### E. F. JOHNSON COMPANY

## Viking Valiant Information Bulletin #1

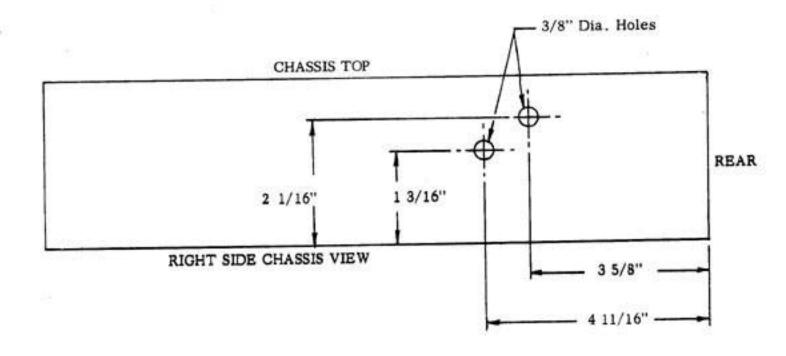
Remove R6 470 ohm, 1/2 watt resistor and C-87 .005 ceramic disc from pin 1 of XV3, 6CL6 socket and the terminal strip TS6. Replace with an insulated wire.

INSIDE CHASSIS VIEW RIGHT SIDE

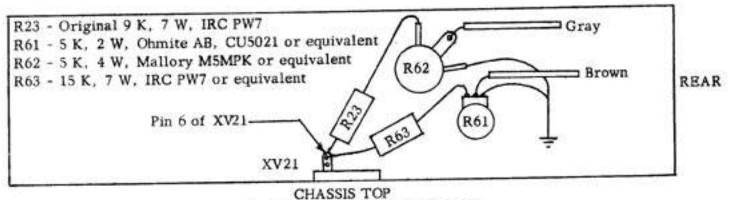
Remove 5 turns from L5 at the end farthest from the chassis.

Turn the slug in L17 counter-clockwise until it is all the way out.

Dress plate lead from L5 directly over socket to pin 6 of 6CL6.

Adjust slug in L5 to obtain adequate drive on 20 through 10 meters.
